Product Change Notification

1. ECR #: 156745
Notification #: 294

- IDSS - INSULATION DISPLACEMENT SOCKET CABLE

New Modified Body Picture 1

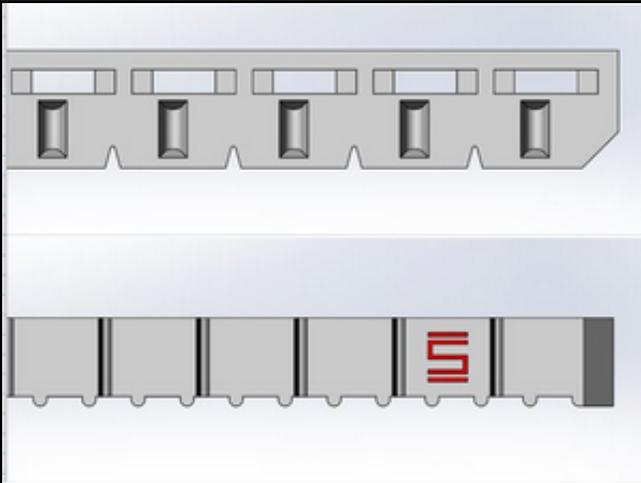
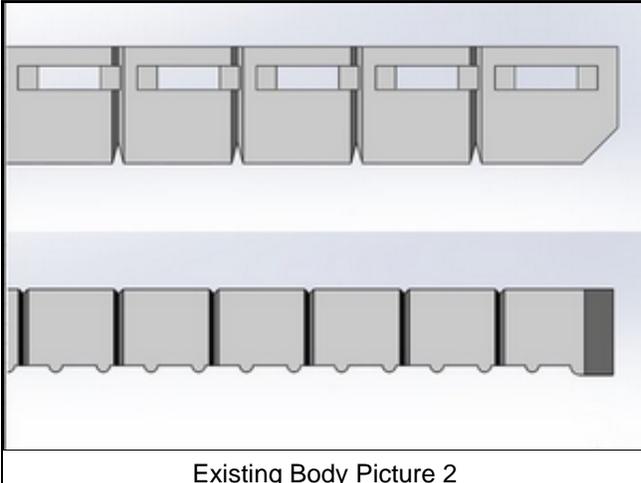
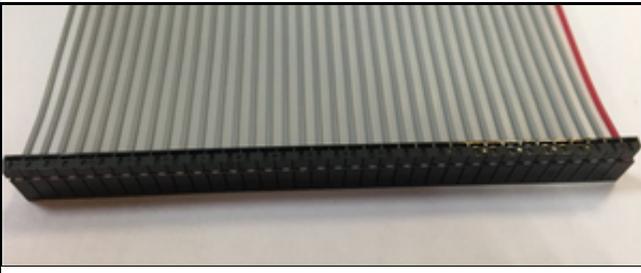
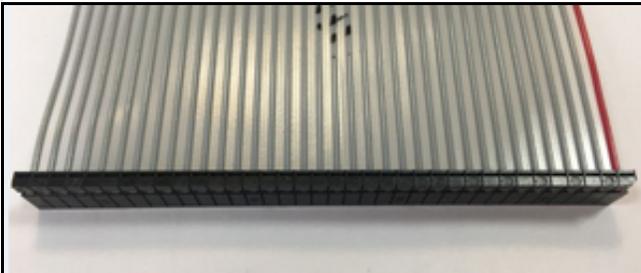
Void coring was added on the top surface.

Visual inspection; voids will be noticed on the top of the body where prior revision had no voids.

<p>New Modified Finish Good</p>	<p>Existing Finish Good</p>
<p>7. Reason for Change: Changes were made to improve dimensional consistency.</p>	
<p>8. Impact of Change on Form, Fit, or Function:</p> <ul style="list-style-type: none"> • Form - this is a rolling change and there is some opportunity for mixed inventory on a limited basis 	
<p>9. Projected Implementation Date: December 08, 2017</p>
